From: Ziegelbauer, Heather/MKE <Heather.Ziegelbauer@jacobs.com>
Sent: Wednesday, February 20, 2019 3:37 PM
To: Neal, Conor; Carey, Angela J - DNR
Cc: Joseph Janeczek; Ryan Suennen; Jeff Danko
Subject: Tyco – Draft Addendum to 2015 Barrier Wall Groundwater Monitoring Plan Update
Attachments: DRAFT_AddendumToBWGMPU-02202019.pdf

Subject	Draft – Addendum to 2015 Barrier Wall Groundwater Monitoring Plan Update
Project Name	Tyco Fire Products LP, Marinette, Wisconsin
Attention	Tyco Fire Products LP
From	Jacobs Engineering Group Inc.
Date	February 2019
Copies to	U.S. Environmental Protection Agency Wisconsin Department of Natural Resources
Document Control No.	704683CH.264

FIGURE 2-1
PROPOSED GROUNDWATER ELEVATION AND TOTAL ARSENIC MONITORING WELLS

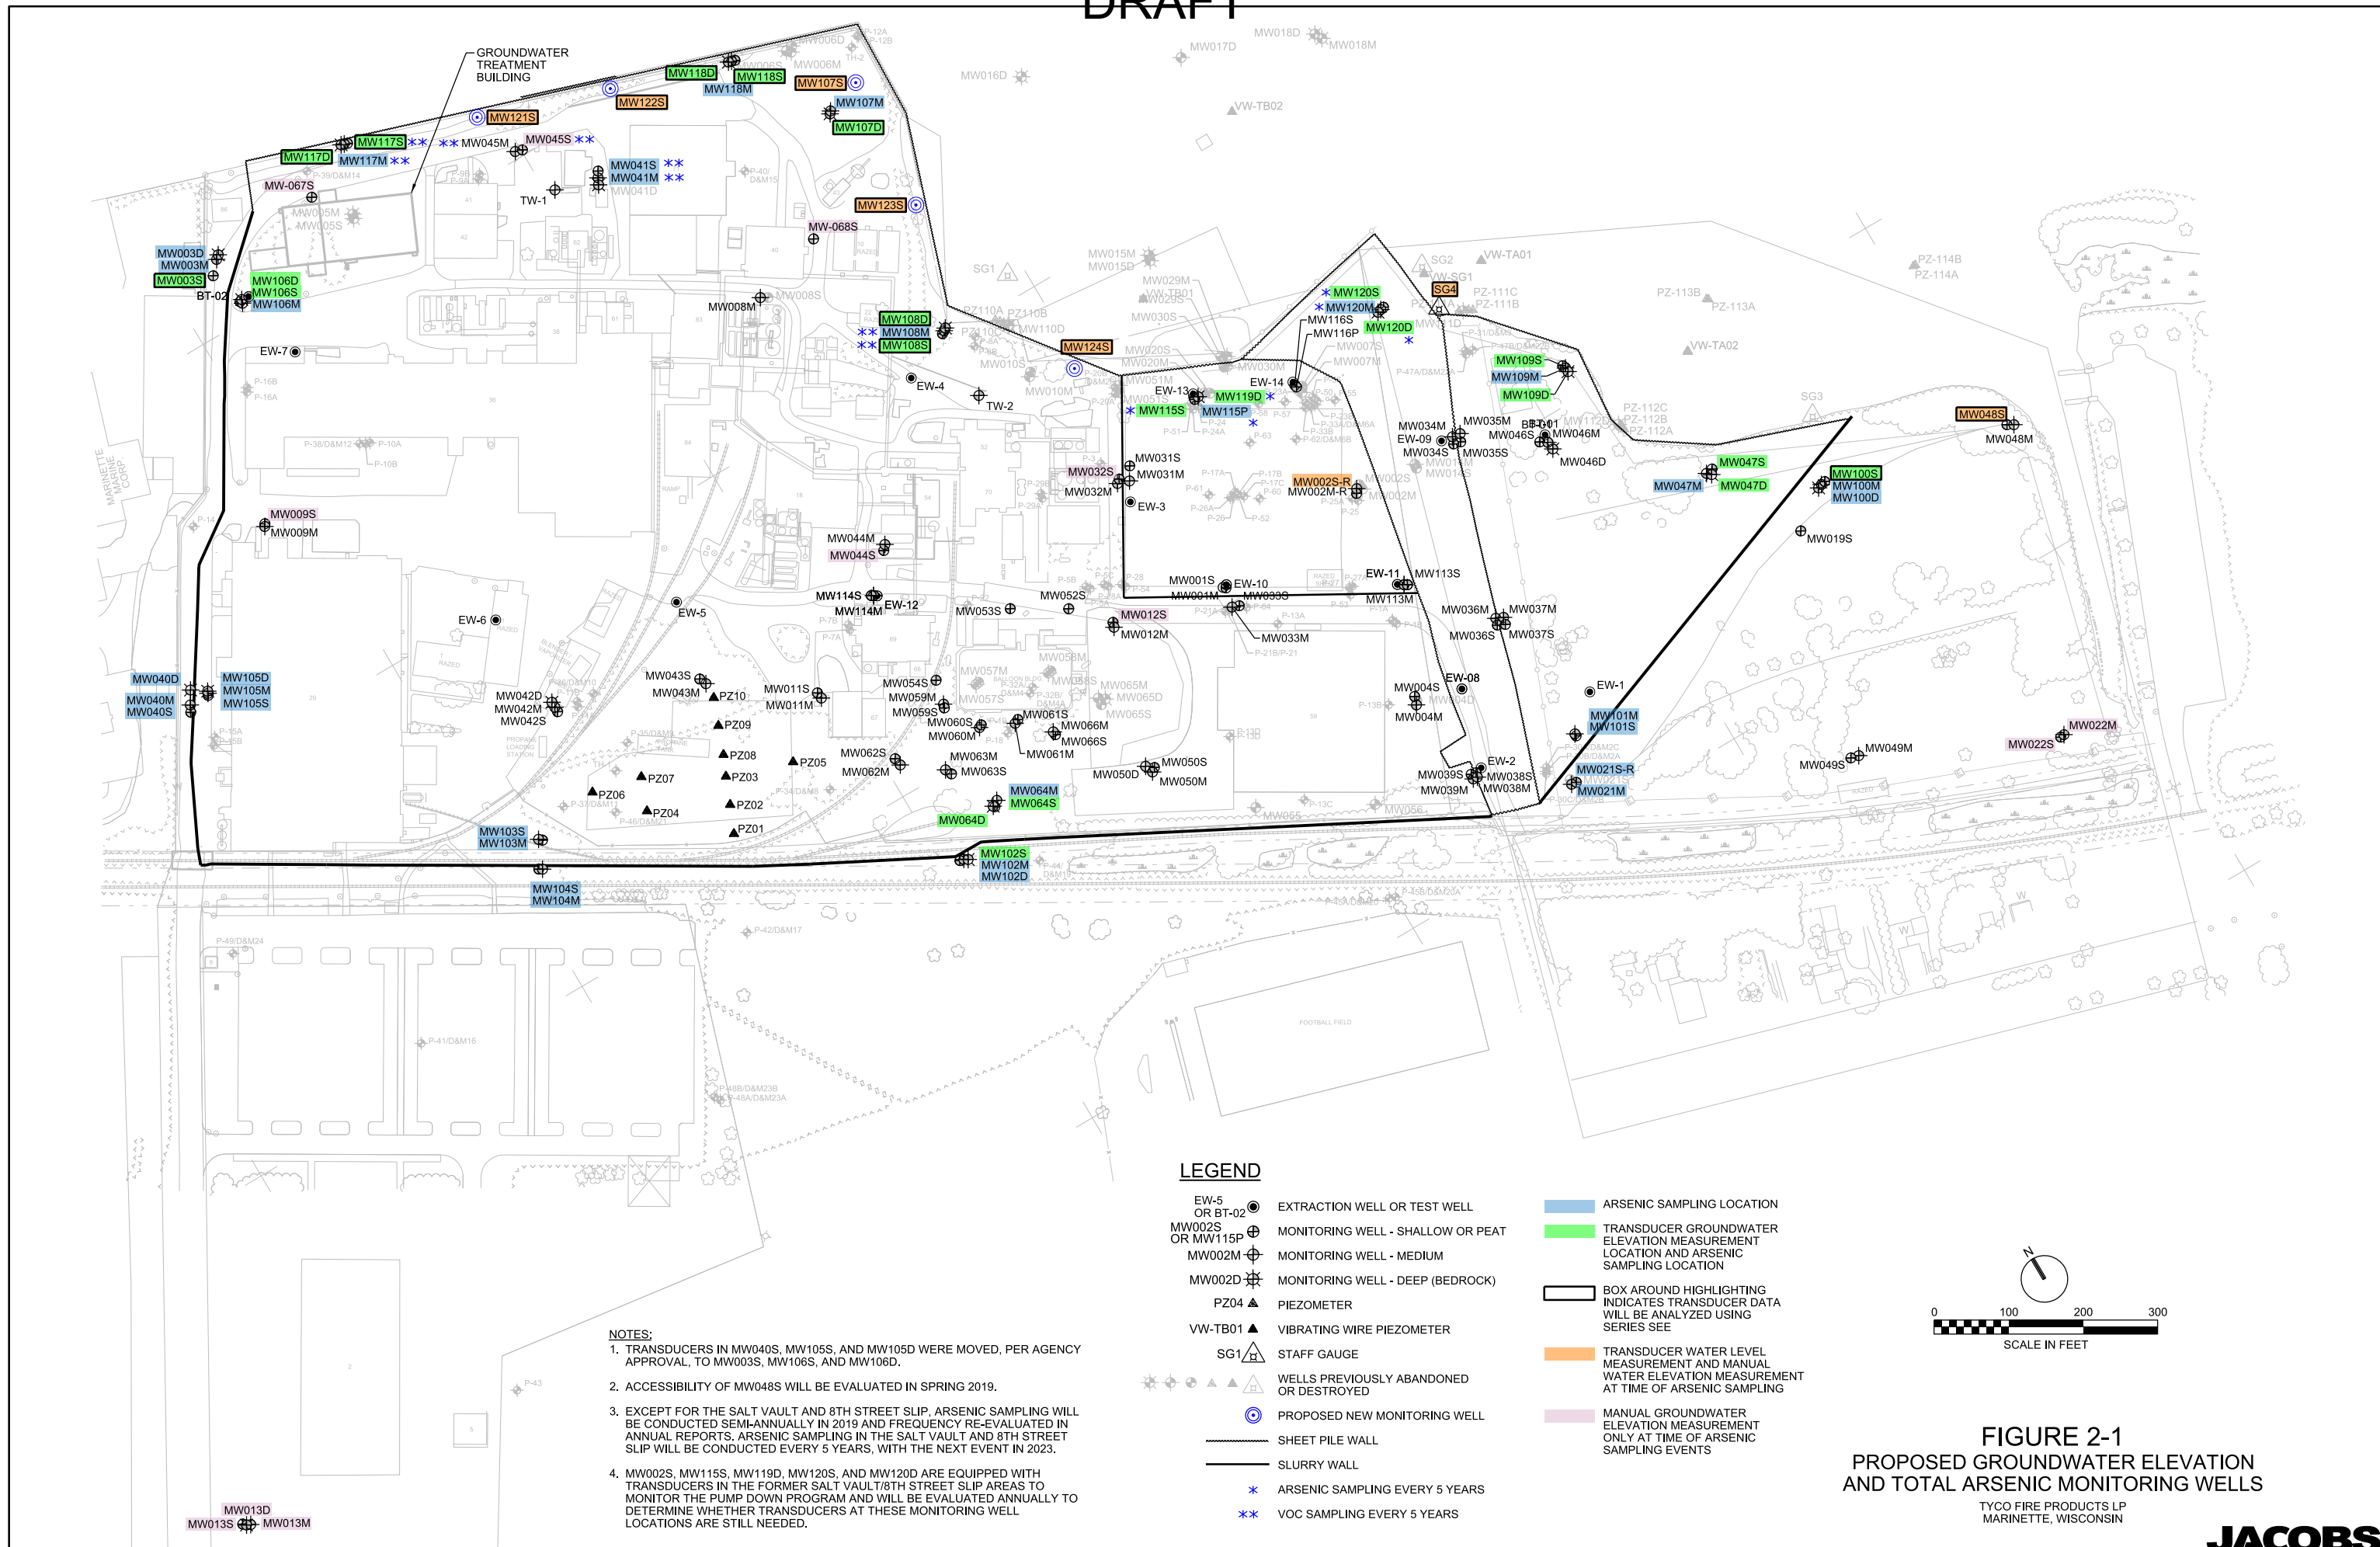
Five new shallow monitoring wells (MW107S, MW121S, MW122S, MW123S, and MW124S) will be installed in the Main Plant to provide a monitoring well network with approximately 200-foot spacing along the VBW near the Menominee River.¹ Such spacing means that a monitoring well will be within 100 feet of a potential Main Plant VBW leak.² Proposed monitoring well installation locations are shown on updated Figure 1-2 and generally spaced every 175 feet, but may have spacing up to approximately 200 feet depending on utility and other obstructions. Well installation, development, and surveying methods are described in the Monitoring Well Construction, Well Development, and Site Surveying portions of BWGMPU Section 2.2.3. To the extent possible, monitoring wells will be installed within approximately 10 feet of the VBW; however, well locations may be adjusted based on site conditions (such as tiebacks, utilities, planned conveyance system, and other obstructions).

Table 2-1 and Figure 2-1 from the 2015 BWGMPU have been updated to reflect the proposed new well locations, manual groundwater elevation monitoring wells, and updated pressure transducer locations.

Figure 2-3. Vertical Barrier Wall Overall Effectiveness Evaluation Flow Chart
Tyco Fire Products LP Facility, Marinette, WI

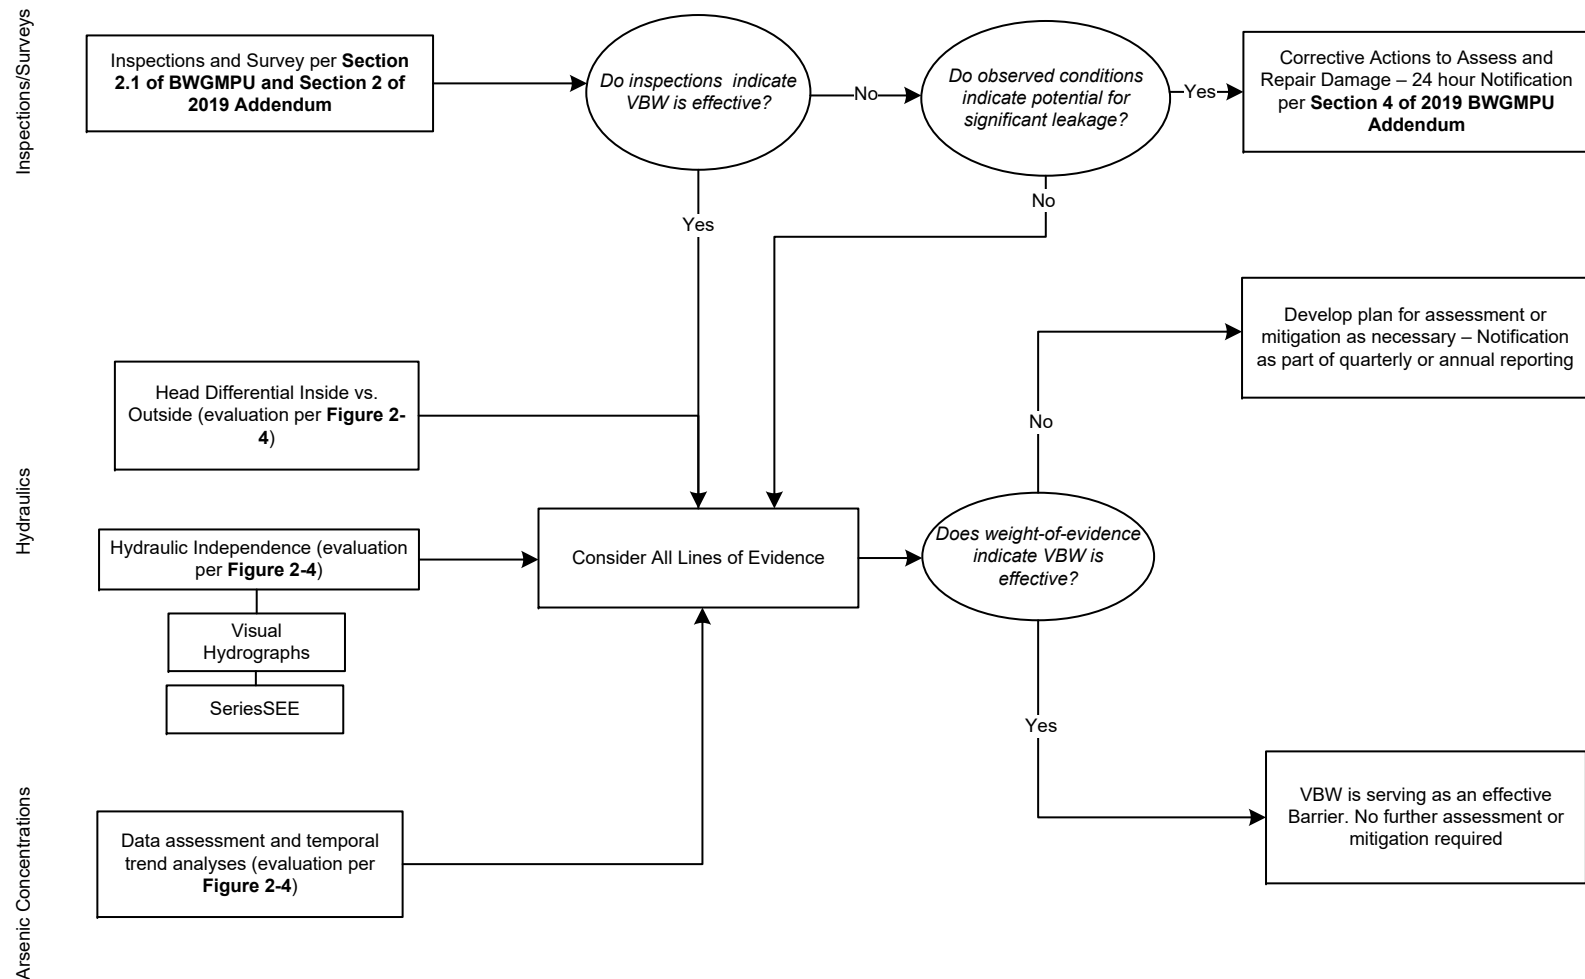
If multiple lines of evaluation indicate a potential leak in the VBW system, additional evaluation or mitigation, as necessary, will be pursued. The following provides additional clarification to potential corrective action steps indicated in BWGMPU Sections 2.1.6, 2.2.6, and 2.3.6 (CH2M 2015) and depicted on updated Figure 2-3.

Figure 2-4. Vertical Barrier Wall Technical Evaluations Flow Chart
Tyco Fire Products LP Facility, Marinette, WI

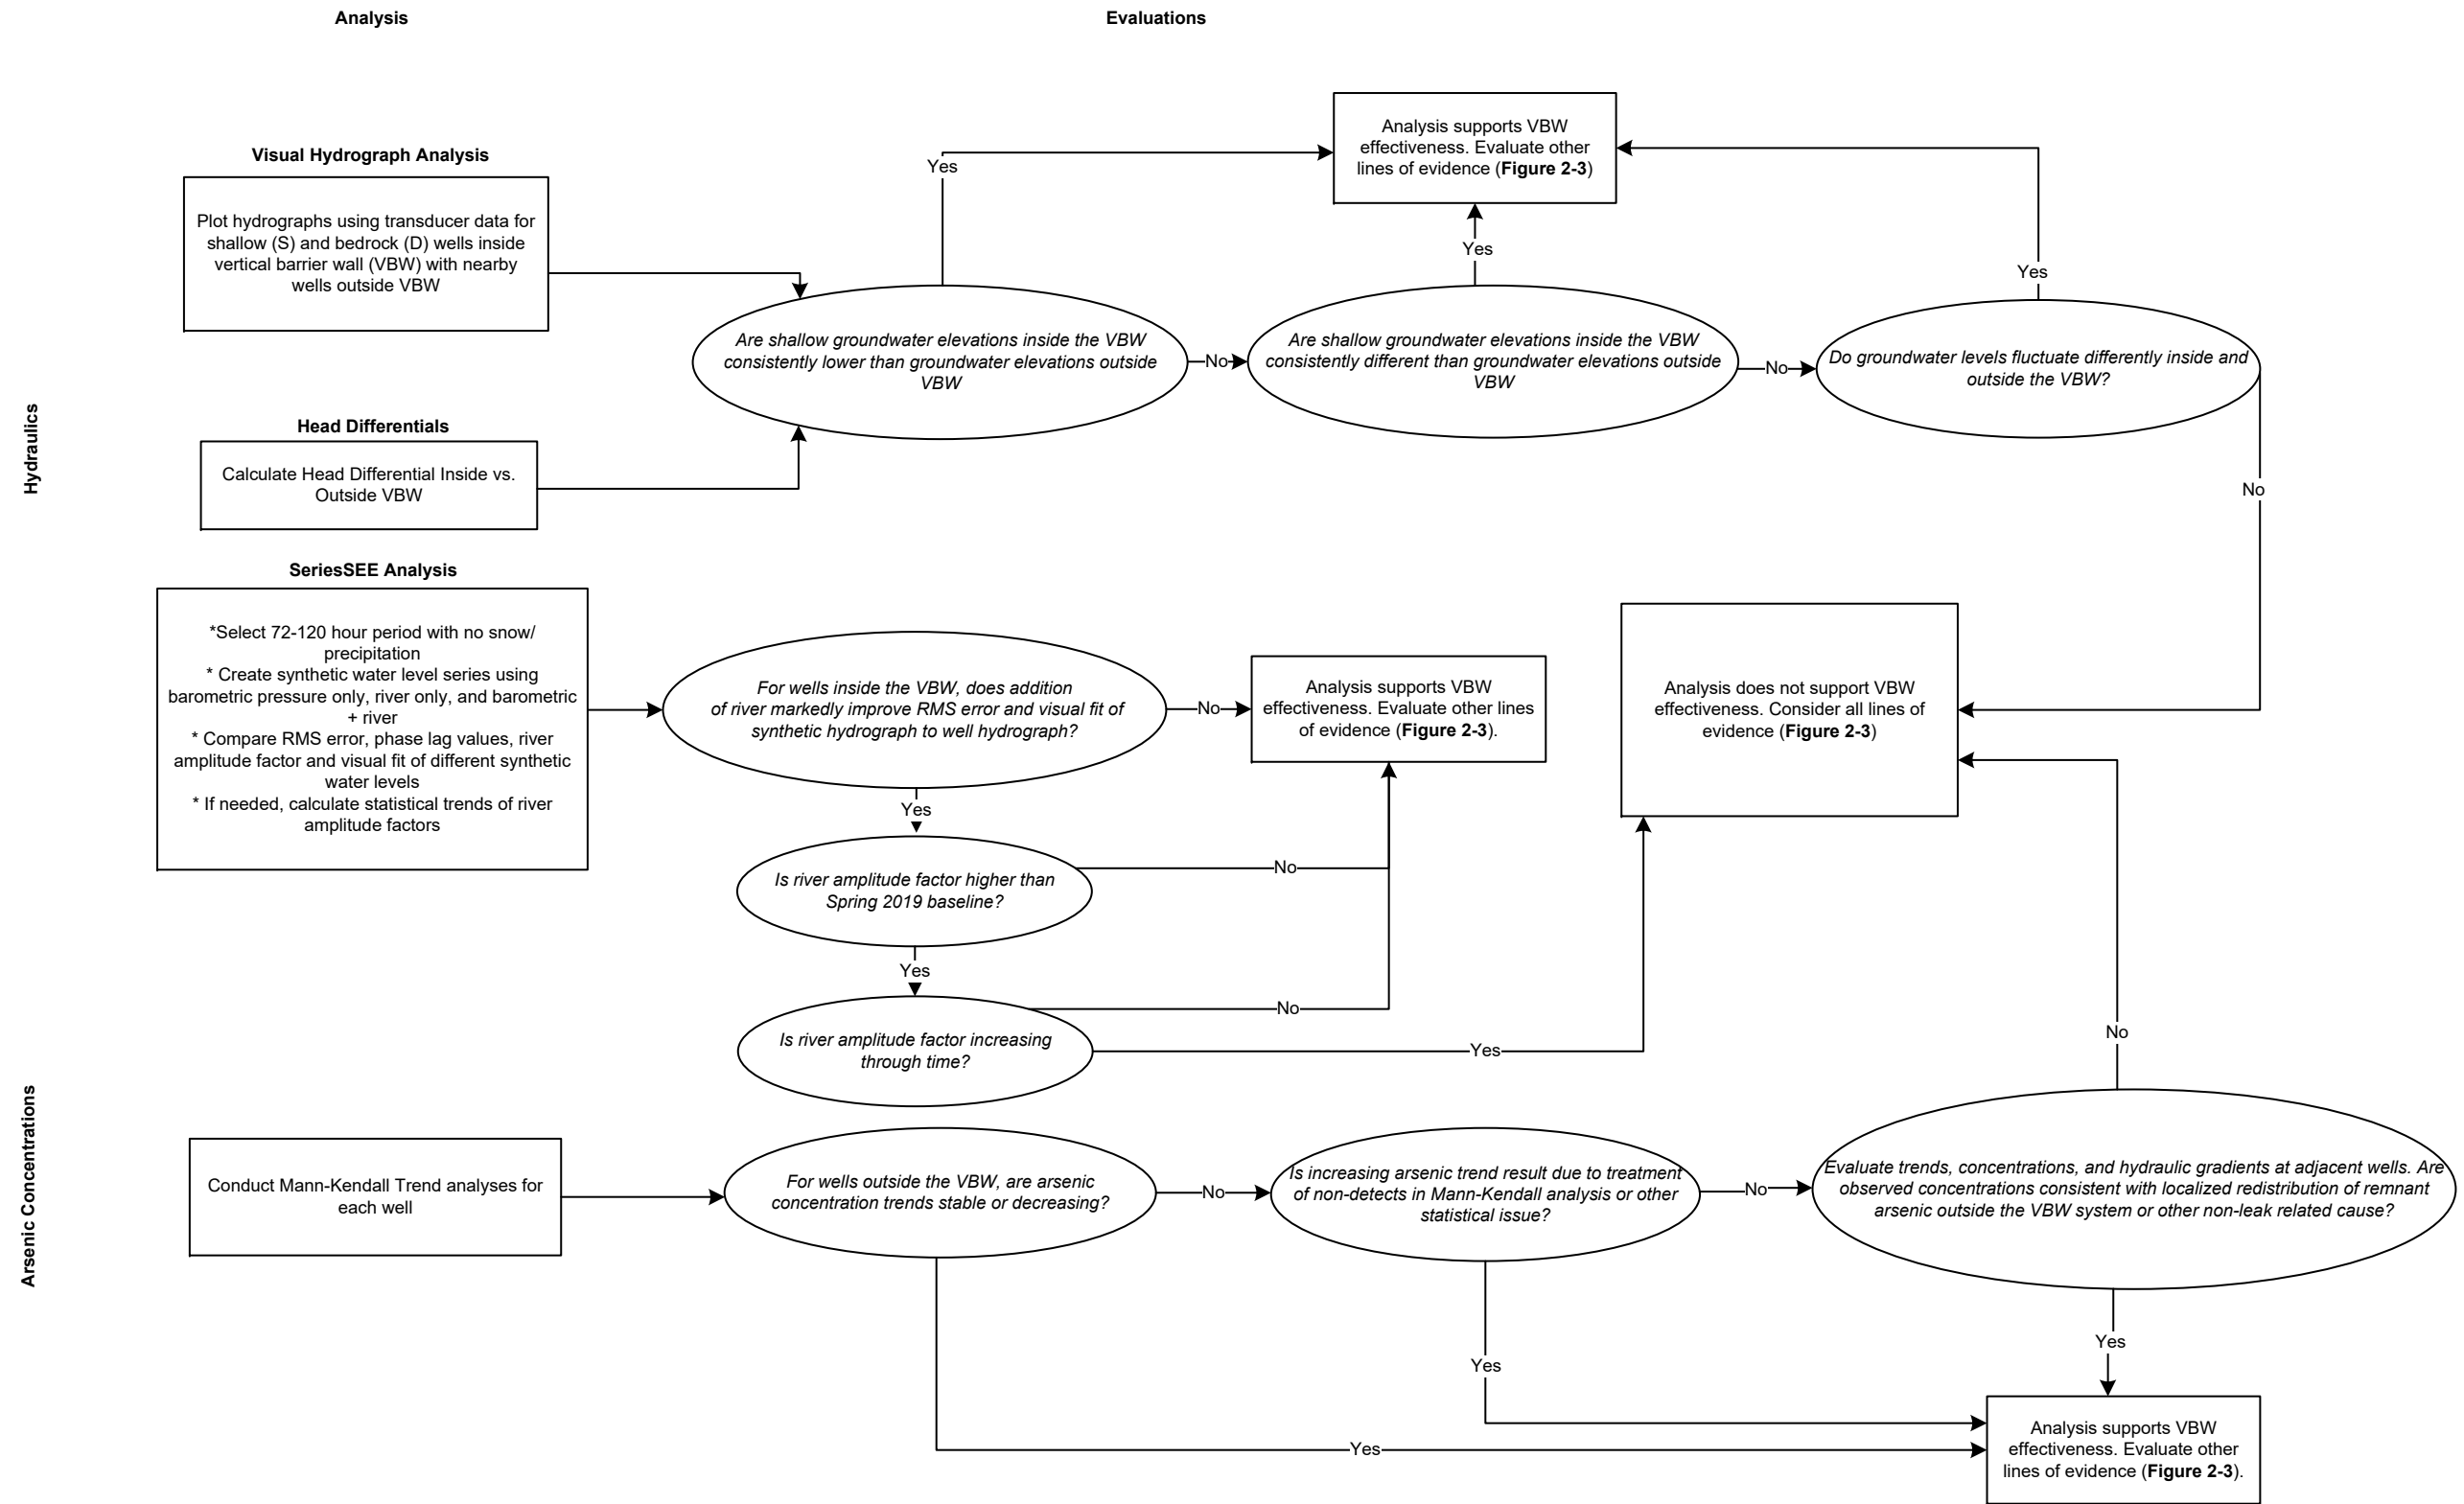
A new decision tree figure summarizing evaluation steps for each line of evidence, including the new SeriesSEE evaluation, is provided on new Figure 2-4.

- Groundwater head differential comparisons inside/outside VBW (as described in BWGMPU Section 2.2.5 and summarized on new Figure 2-4)
 - Groundwater contour maps for shallow and deep monitoring wells (as described in BWGMPU Section 2.2.5) but may be dropped in the future if SeriesSEE and VBW underwater inspection are deemed sufficient to evaluate VBW effectiveness

- Visual comparison of transducer hydrographs for wells distant from the river (as described in BWGMPU Section 2.2.5 and summarized on new Figure 2-4).

- The new SeriesSEE transducer analysis for select Main Plant wells adjacent to the river (summarized on new Figure 2-4)
- Groundwater arsenic monitoring, including temporal trend assessment, evaluation of hydraulic gradient direction and magnitude, comparison of concentrations inside and outside wall, and evaluation of localized redistribution of arsenic outside VBW (as updated on new Figure 2-4)⁸
